Free Route Airspace
Deployment 1

Gateway documentation:
Stage 4 Submit

Step 4A Update Design:
Consultation Response Document

Figure 1. 3LNCs identified with EU Network Manager with neighbouring state conflict (SUM & BEL)

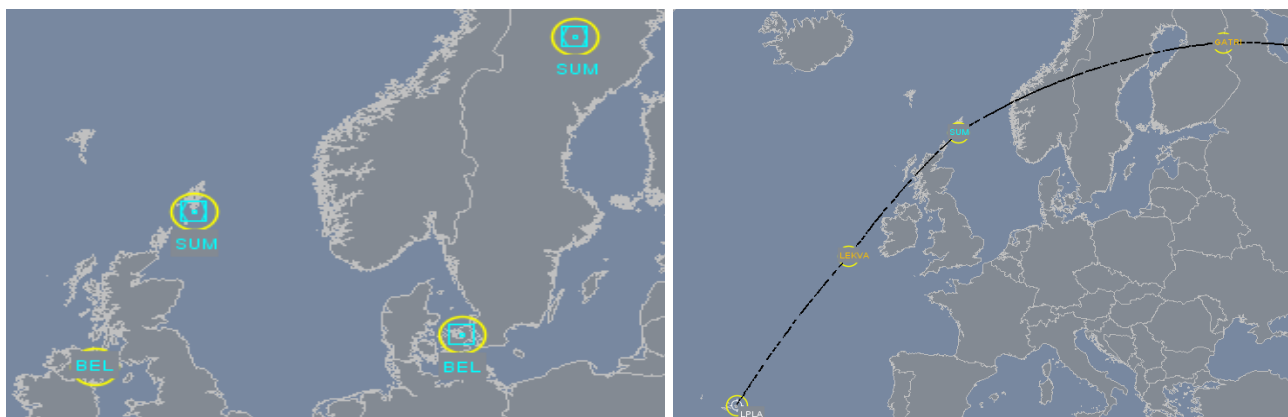
Summary of Issue		Outcome and Final NATS Response
2a	To address the EU Network manager recommendation to all ECAC States to remove or collocate 5 /3 letter name codes as current flight plan acceptance systems are unable to differentiate between Nav aids having identical 3LNCs.	Where 3LNCs produce a conflict with neighbouring States, agreement will be made between the States and EU Network Manager not to publish these as FRA points. It is identified that only 2 of these 3LNCs produces a conflict with neighbouring States (SUM – Denmark; and BEL- Sweden). See Technical Annex 1.1 for diagram. Agreement has been reached with EU Network Manager, Sweden and Denmark that neither countries shall publish BEL or SUM as FRA points.
2b	To address the issue of misunderstanding and potential garbling effect as a result of the potential dual use of both 5LNC and 3LNC points that would co-exist in the same position.	Additionally, where lower route connectivity is associated with such points the name of these points shall be changed to a geographically unique 5LNC point; thereby producing seamless flight plan connectivity between the FRA volume above and the route structure below.

In the FRA and lower route environment, 2 current 3LNC navigation points (SUM and BEL) will be removed and replaced with 5LNC (WAFIL and BELZU).

2 of the 14 3LNCs are identified as producing a confliction with neighbouring States (SUM and BEL) as shown in Figure 1 below:

Figure 2: ATS Route connectivity for BELZU and WAFIL

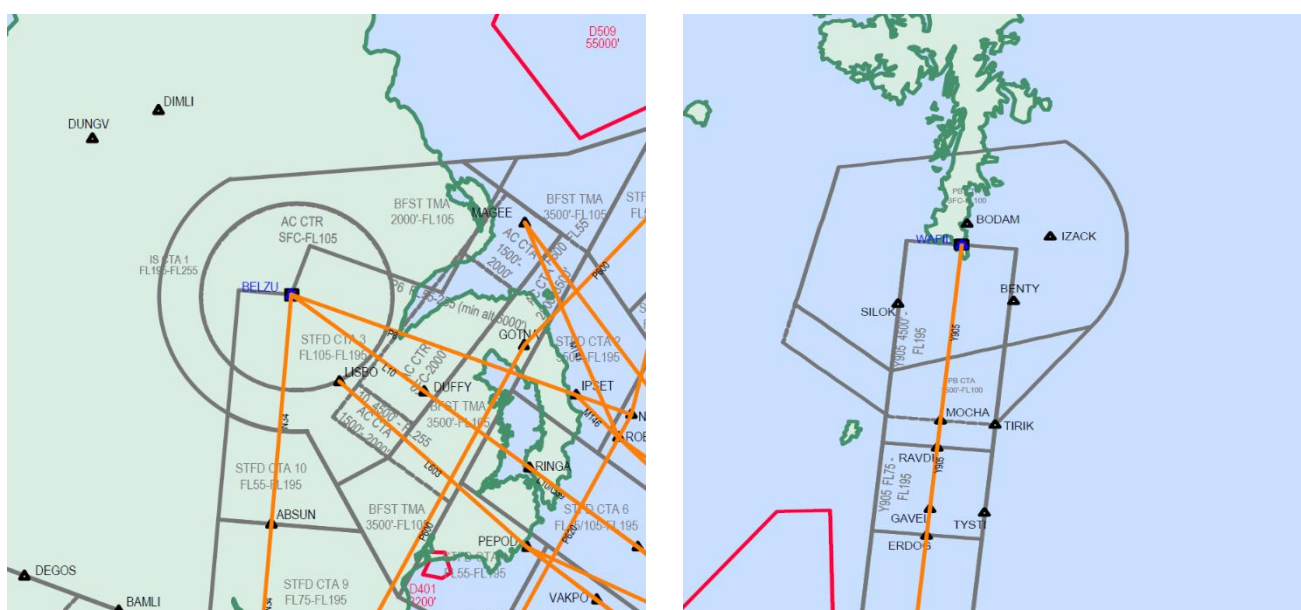
As both BEL and SUM reside at the end of lower routes, amendments to lower route information contained within ENR 3.1 and 3.3 will be amended accordingly, as shown below for BELZU and WAFIL. This table shows the amendments for ENR 3.1 and 3.3; the diagram shows route connectivity

Route Amendment									
Route Designator	Insert Point	Co-Ordinate	Remove Point	Co-Ordinate	Level Change Point	Level Amendment	IFR Cruising Levels		Remarks
							Even	Odd	
L10	BELZU	543940N 0061348W	BEL	543940.12N 0061347.67W	N/A	N/A	N/A	N/A	ENR 3.3 Amend Note 19 FRA EX

N34	BELZU	543940N 0061348W	BEL	543940.12N 0061347.67W	N/A	N/A	N/A	N/A	ENR 3.3 Remove Note 4
P6	BELZU	543940N 0061348W	BEL	543940.12N 0061347.67W	N/A	N/A	N/A	N/A	ENR 3.3 Delete Note 5 (DRA Fix)
Y905	WAFIL	595244N 0011712W	SUM	595243.34N 0011711.49W	N/A	N/A	N/A	N/A	ENR 3.1
